**TRANSMITTAL OF REVISED AESTHETIC BARRIER WORK PLAN**

**DRAFT RESPONSES TO THE OHIO EPA COMMENTS ON THE  
INSTALLATION OF AESTHETIC BARRIER WORK PLAN  
FERNALD ENVIRONMENTAL MANAGEMENT PROJECT**

# INSTALLATION OF AESTHETIC BARRIER WORK PLAN

20900-WP-0001  
REVISION 0  
FINAL

FIGURE 2. AESTHETIC BARRIER ALONG WILLEY ROAD

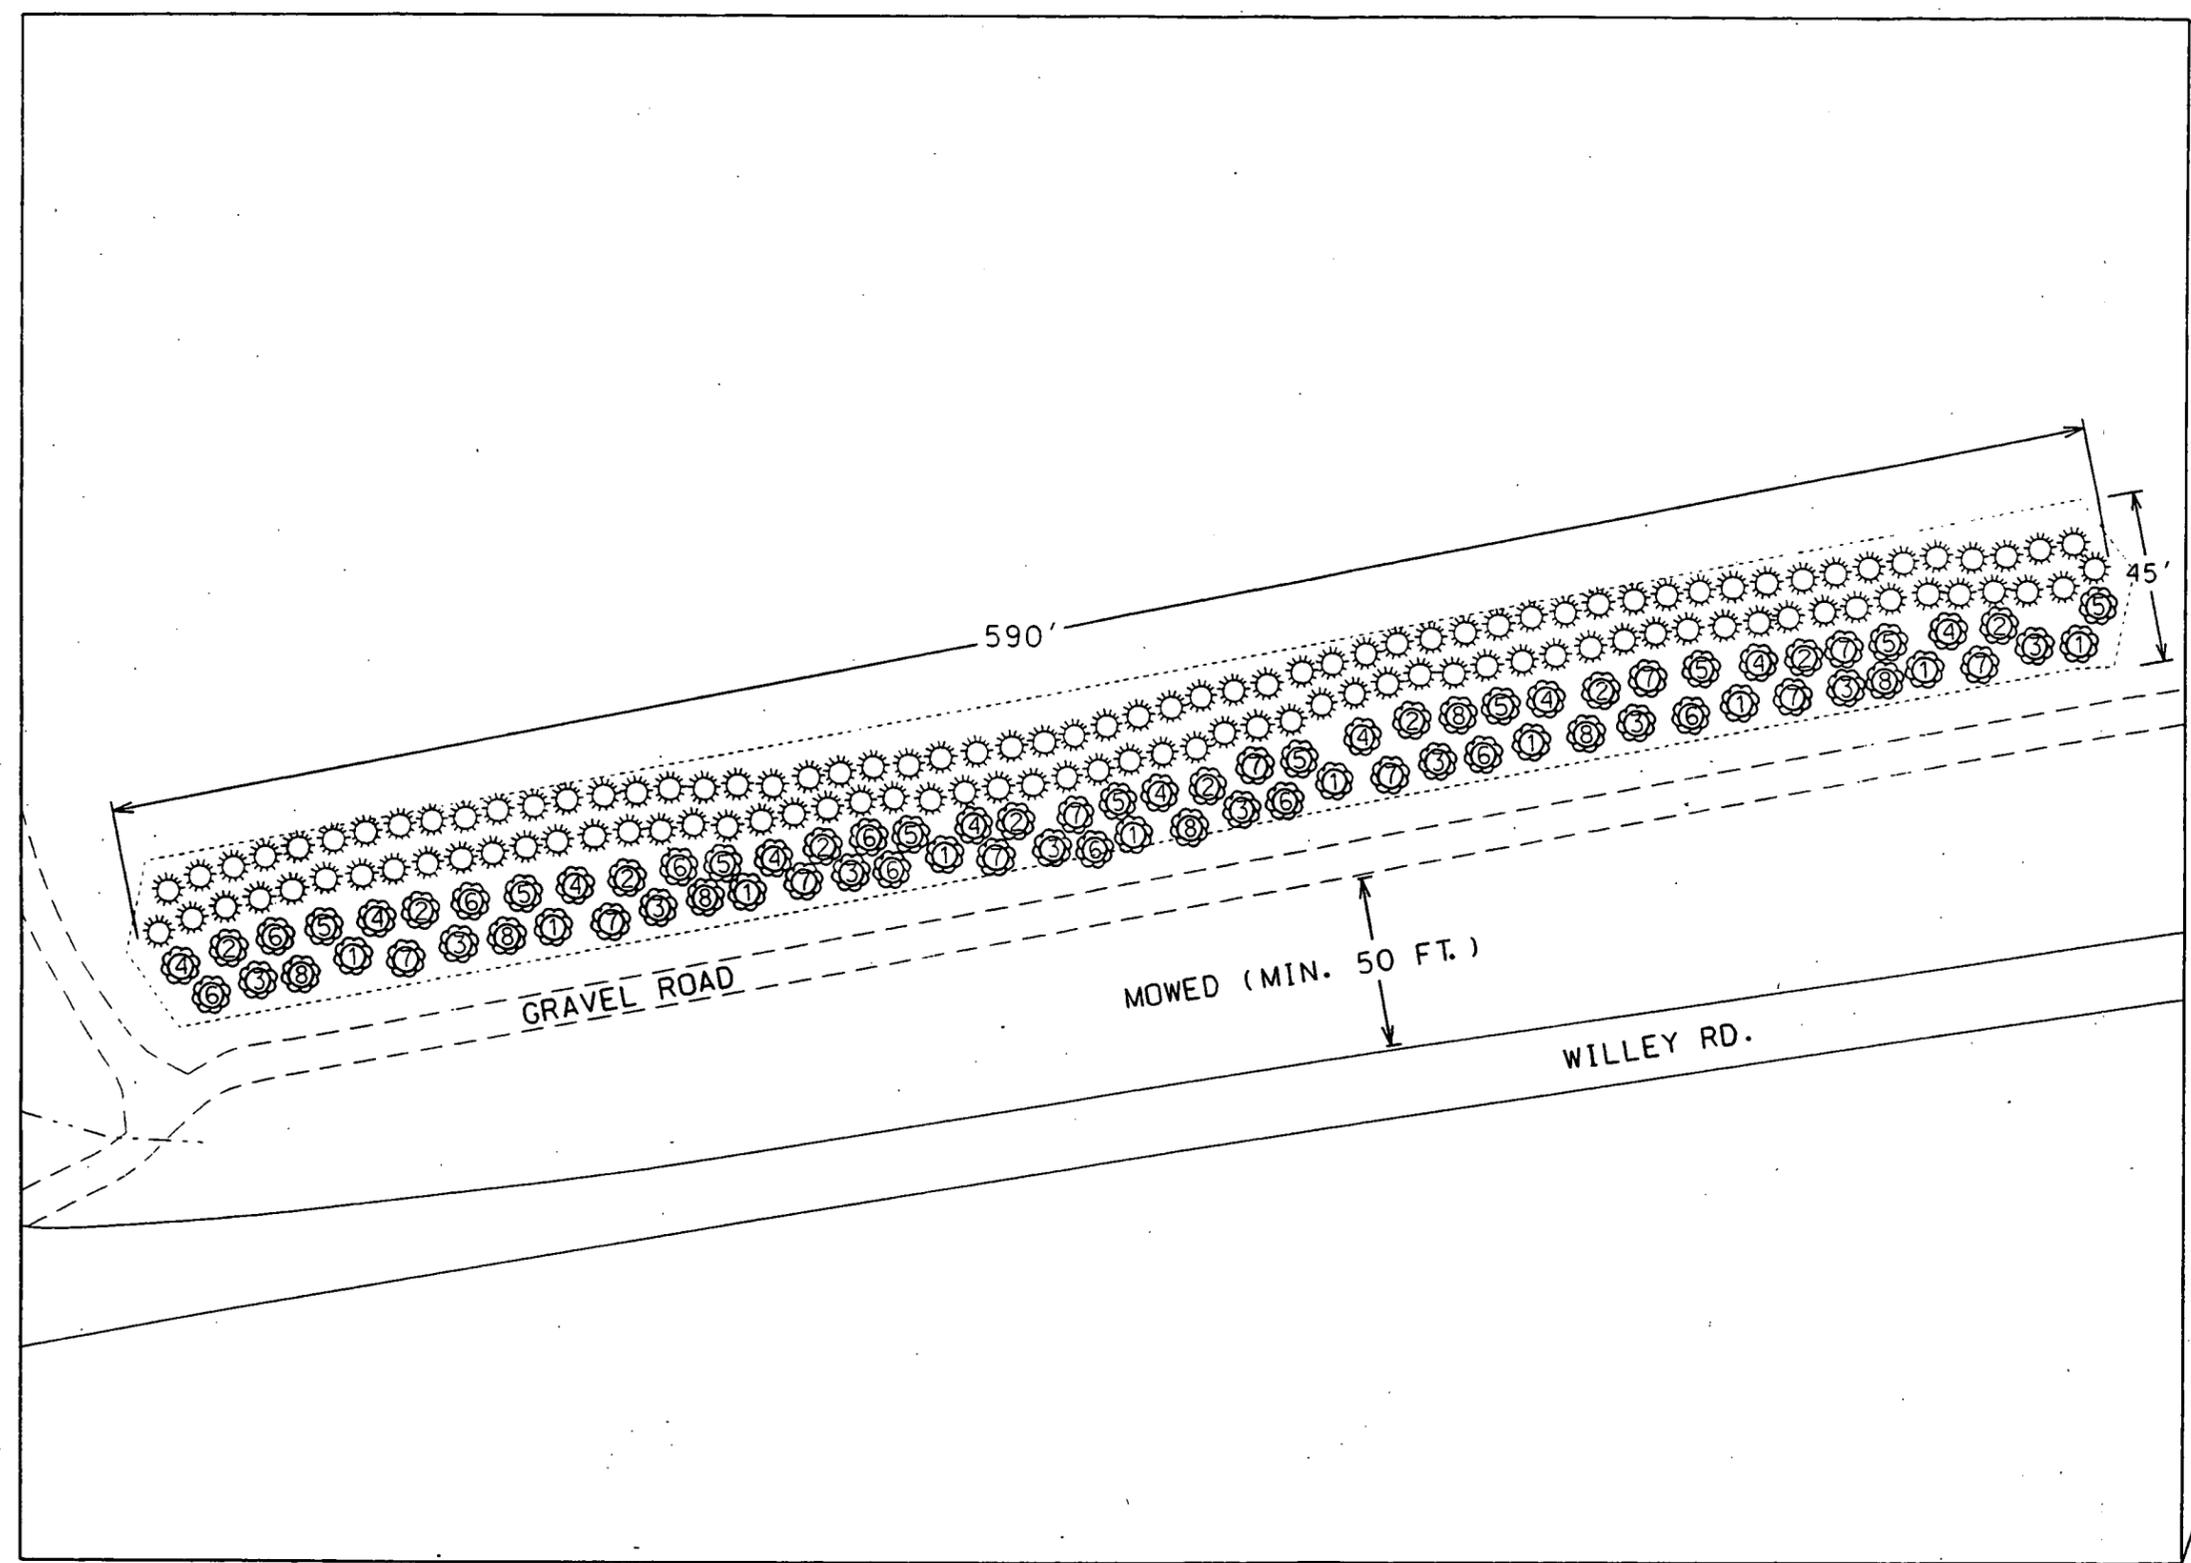
Section #: Figure 2

Comment: Ohio EPA recommends termination of mowing between the barrier and the property boundary. Seeding of the area with native grasses and forbs is a good alternative to the proposed old field.

Response: DOE will refrain from mowing between the barrier and the existing gravel road used for access to groundwater wells, however, mowing will be necessary between the gravel road and Willey Road for safety reasons.

Action: DOE will eliminate of mowing between the barrier and the existing gravel road and revise the work plan to reflect this.
